Steering Committee for Implementation of Appendix VIII, ASME Code Section XI

SUBJECT: NRC ASSESSMENT OF THE PDI PROGRAM

**RESPONSES TO
NRC ASSESSMENT OF THE PDI PROGRAM
OPEN ITEMS**

FGU's - P308 Specimens Only

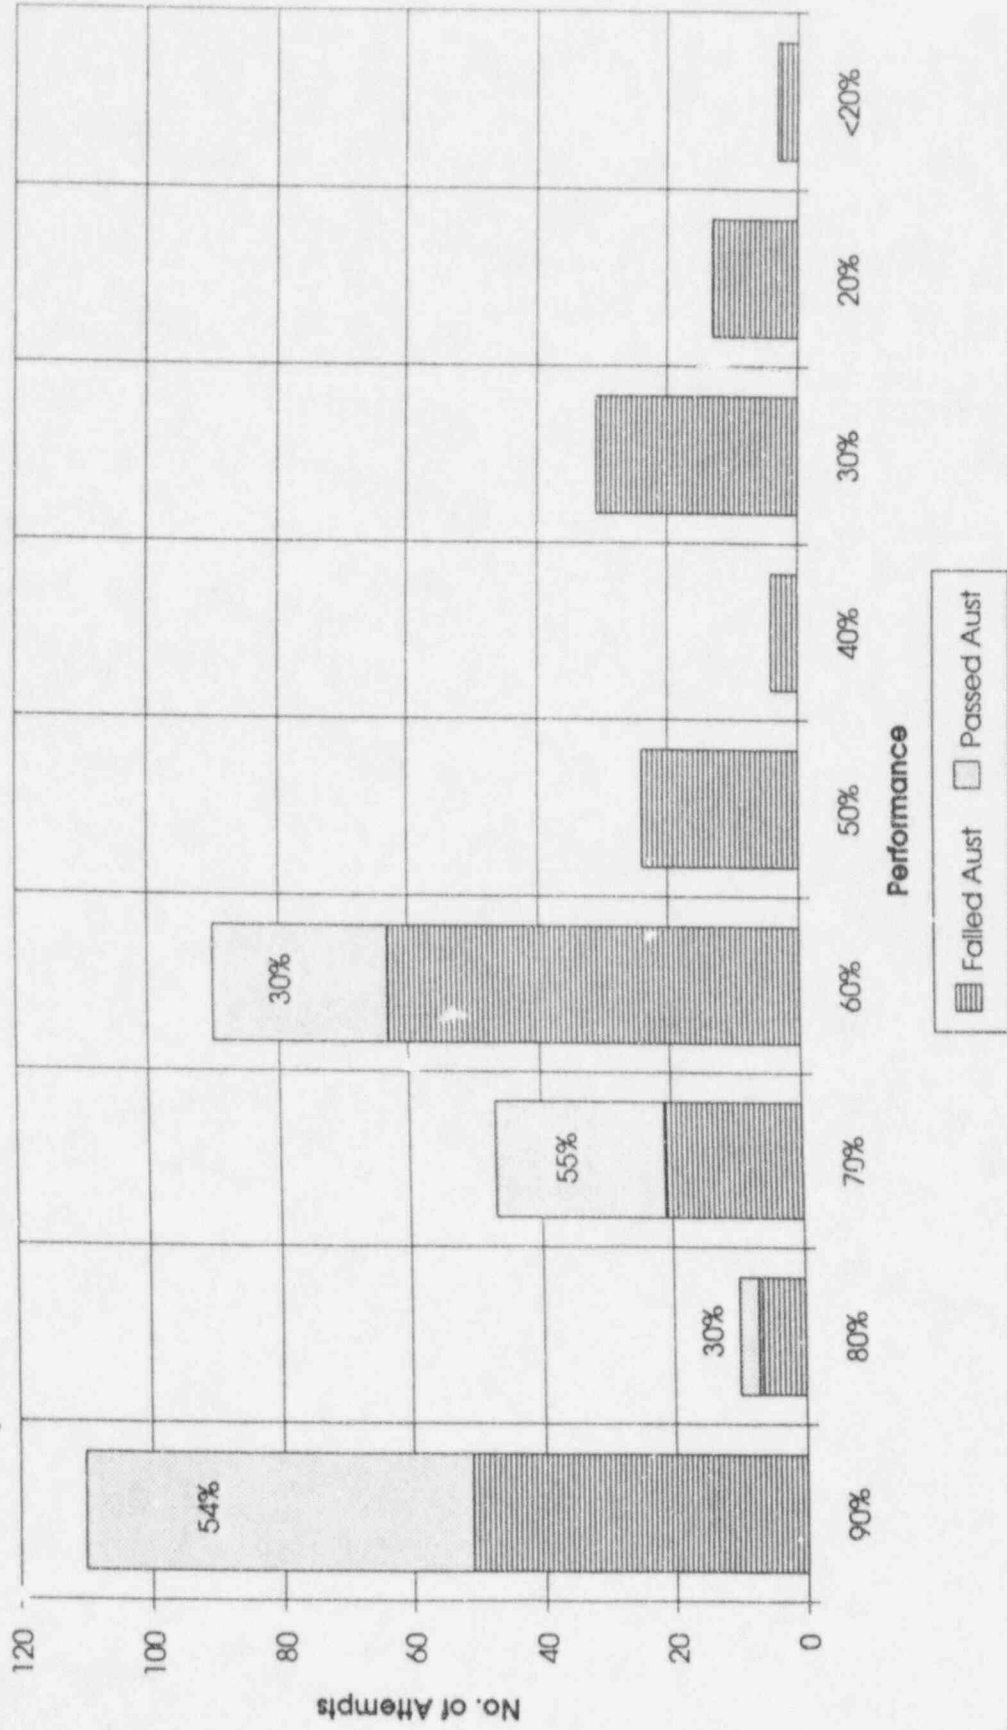
The Code does not address IGSCC or single side access acceptance criteria in the supplements. Therefore, PDI established the acceptance criteria which the team considered weak and in need of improvement.

A revised policy was implemented immediately following the exit interview by the NRC Assessment Team, in January of 1995. It is now a requirement that each candidate must find at least 2 of 3, 3 of 4, or 4 of 5 IGSCC or far side only access flaws before they are given credit for these conditions. If they fail this criteria but pass the Supplement 2 acceptance criteria, they may be given an additional 5 flaws. The candidates must then correctly identify at least 4 of 5 of the flaws in the supplemental examination before they may receive IGSCC or single side access endorsements.

The performance on IGSCC samples is shown in Figure 1. The performance on flawed grading units is shown for candidates who passed or failed the total austenitic test (with IGSCC option). The first bin (90-100%) contains the results for detections 3 of 3 or 4 of 4. Both passed and failed candidates are listed. The Percentage number in the top bar is Passed divided by total candidates in that bin. Candidates who detect 100% of the IGSCC flaws in their test have only a 54% chance of passing the whole austenitic test. This decreases to 30% for those who detect 2 of 3 IGSCC flaws (60-70% bin). The individuals who failed may have failed for several reasons including: false calls, or missed detections on the remainder of the examination. Figure 2 depicts the performance on unflawed IGSCC grading units in a manner similar to Figure 1. The total number of unflawed IGSCC grading will normally vary from 6 to 10 units which is at least twice the number of unflawed grading units. Again, performance at 90% to 100% provides only a 57% probability of passing the remainder of the test. Calling 60 to 70% of the unflawed grading units correctly provided only a 31 % chance that the candidate would pass the

examination. Figures 3 and 4 provide the same data for the entire test set including the 308 IGSCC samples. The dual acceptance criteria is more challenging than one might assume. Candidates with a false call rate of greater than 10% have at best a 34% chance of passing the overall criteria. Candidates who have a detection rate of 70 to 80% have only a 31% chance of passing the overall criteria.
